Bulletin 1

(10/9/07)

Generic Detail for the RTU Opening Framing

Attached are the generic details for the RTU opening framing for all buildings at Pier Park. These details are being provided as a guide only. Your registered architect or engineer must verify and seal the drawings and details.

ROOF PLAN A

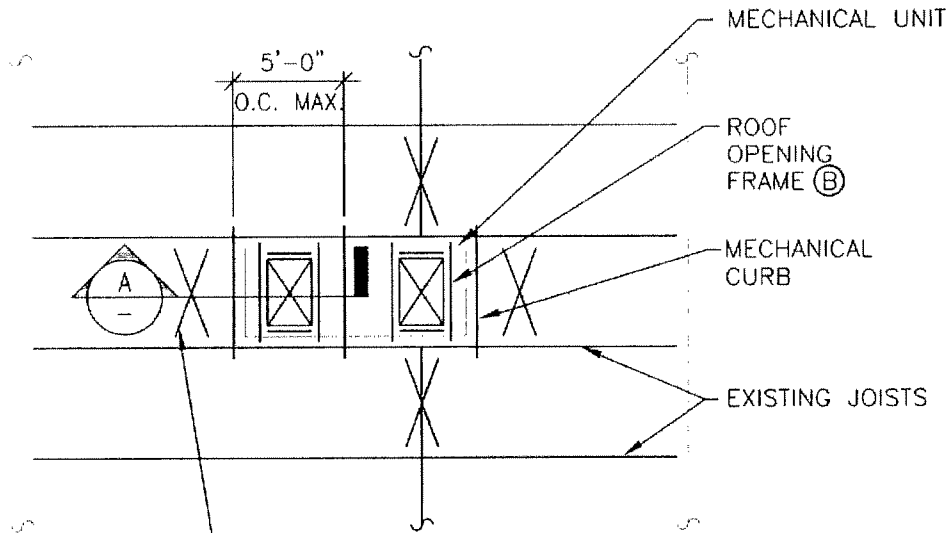
NOTE: IF BRIDGING IS CUT BY DUCT OPENING ADD ADJACENT X BRIDGING TO REPLACE TYPICAL.

ROOF PLAN B

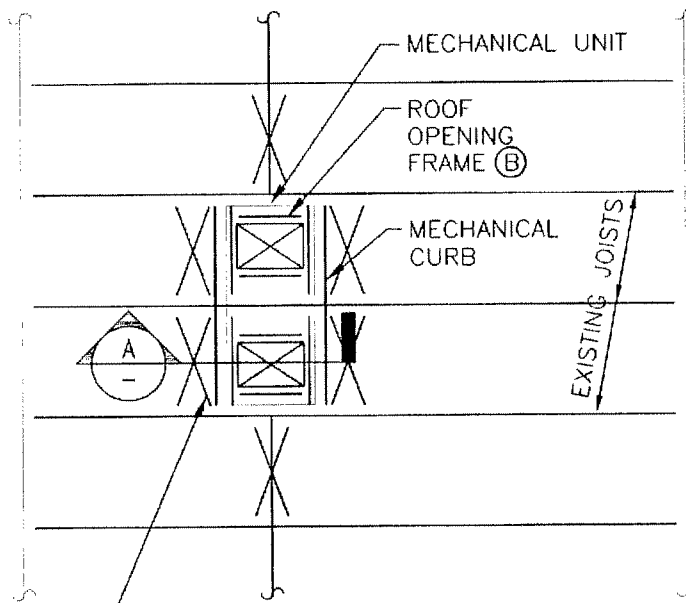
NOTE: IF BRIDGING IS CUT BY DUCT OPENING ADD ADJACENT X BRIDGING TO REPLACE TYPICAL.

ROOF PLAN C

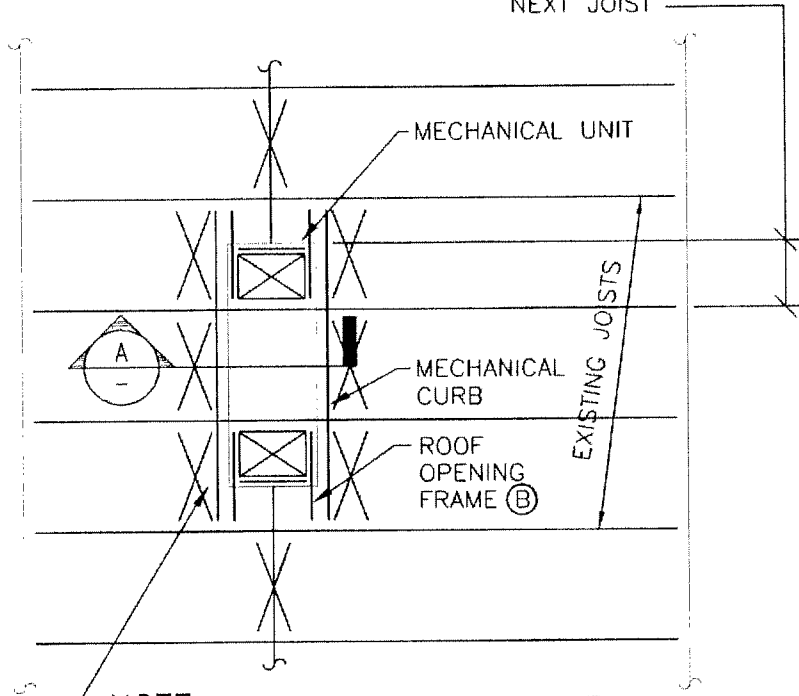
WHEN RTU OVERHANG
EXCEEDS 1'-0", EXTEND
MECHANICAL CURB TO
NEXT JOIST

NOTE: IF BRIDGING IS CUT BY DUCT
OPENING ADD ADJACENT X BRIDGING
TO REPLACE TYPICAL.

ROOF PLAN D

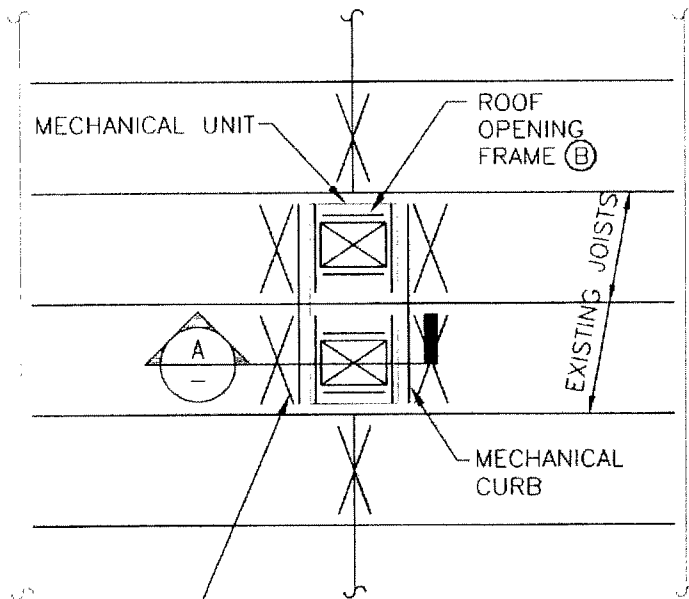
NOTE: IF BRIDGING IS CUT BY DUCT OPENING ADD ADJACENT X BRIDGING TO REPLACE TYPICAL.

TYPICAL ROOF OPENING DETAIL

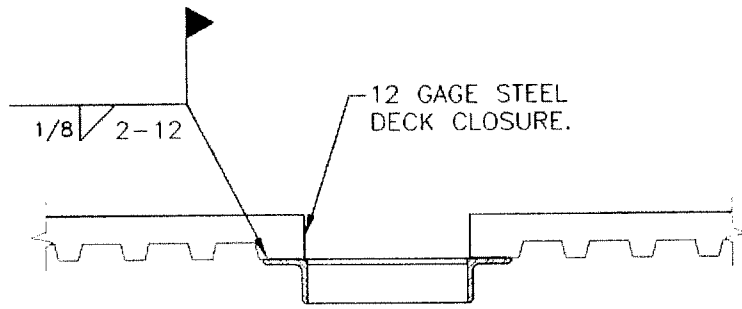
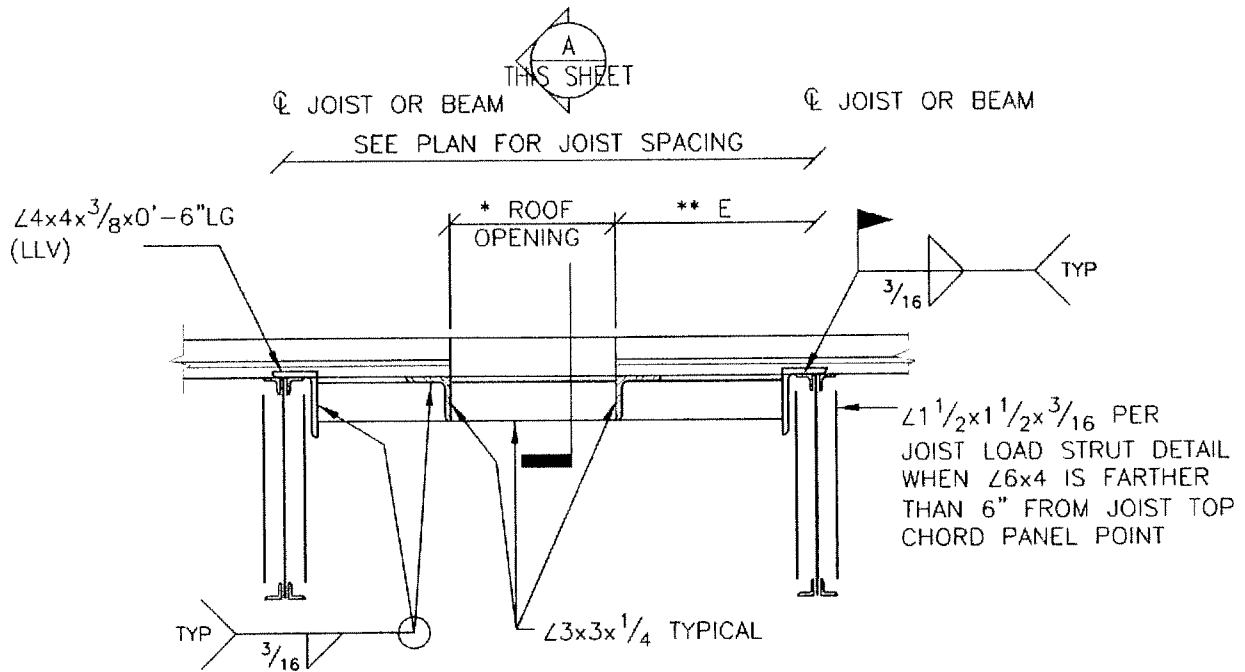
1. THESE DETAILS ARE BEING PROVIDED AS A GUIDE. YOUR REGISTERED ARCHITECT OR ENGINEER MUST VERIFY AND SEAL THE DRAWINGS AND DETAILS.
- * FOR ALL ROOF OPENINGS 12" OR GREATER COORDINATE W/ARCHITECT & MECHANICAL CONTRACTOR FOR OPENING SIZES & LOCATIONS.
REINFORCE OPENINGS LESS THAN 12" BY WELDING 18 GAGE SHEET METAL 12" WIDER THAN OPENING TO ROOF DECK.
- ** WHERE EDGE DIMENSION IS LESS THAN 6", ADJACENT $L3\frac{1}{2} \times 3\frac{1}{2}$ MAY BE OMITTED.
